Subject: Response to Submissions request for comment – 200 Aldington Road, Kemps Creek (SSD-10479)

Attachment A – EES comments on Response to Submissions for 200 Aldington Road Industrial Estate (SSD-10479)

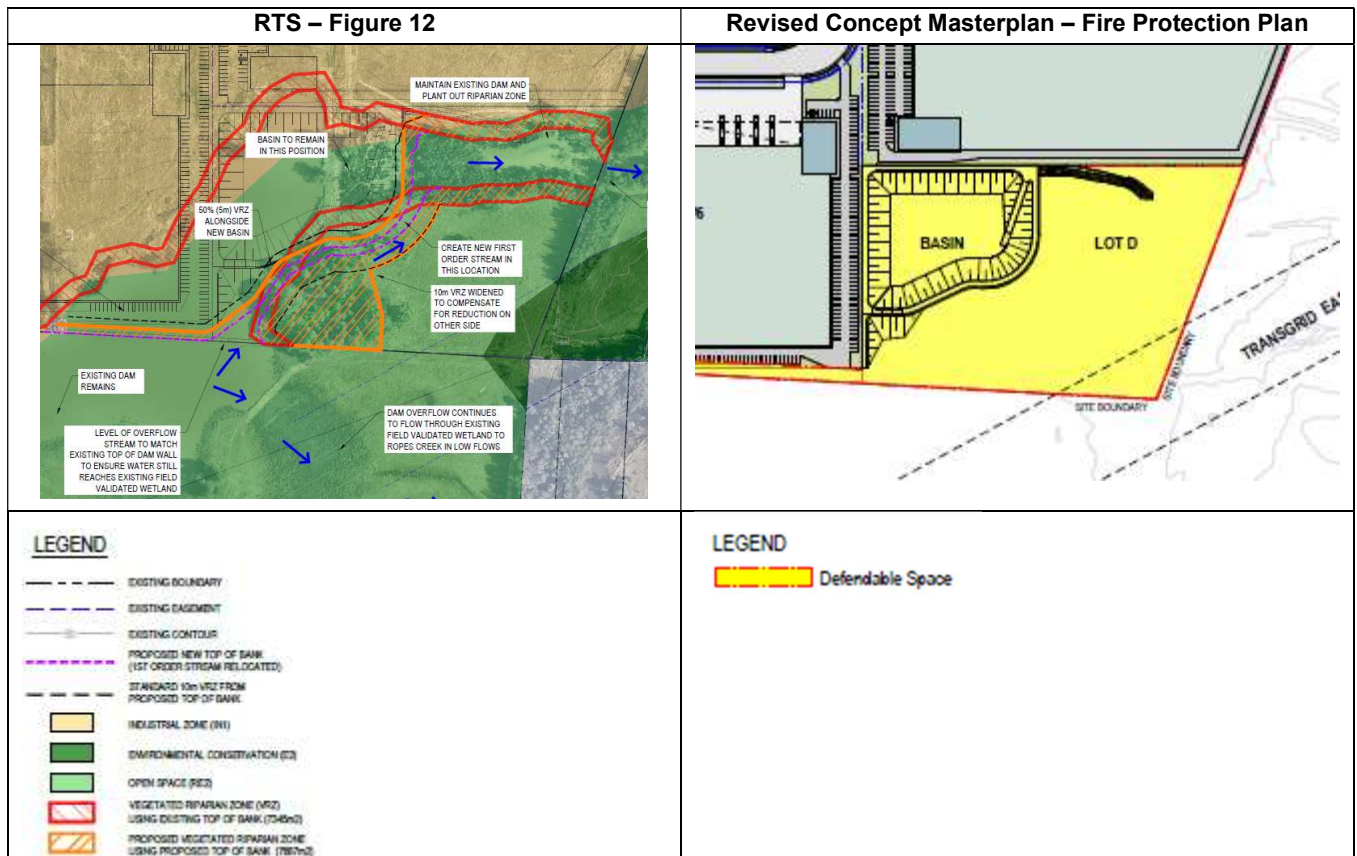
- riparian corridor recreated and first order stream redirected with a 10m buffer on each side (Figure 12, p14), and
- the open space edge road deleted and landscaped edge solution proposed which “provides an acceptable buffer to the riparian corridor” (p22).

It isn't clear from Figure 12 of the RTS (below) if the alteration of the first order watercourse will impact River-flat Eucalypt Forest and Swamp Oak Floodplain Swamp Forest, and this has not been documented in the BDAR.

EES recommends the BDAR be revisited to ensure that the impacts of the proposed works within and adjacent to Lot D are accurately assessed and presented. The assessment must include:

- realignment of the watercourse and recreation of the riparian corridor
- construction of stormwater detention basin
- retaining walls, and
- APZs.
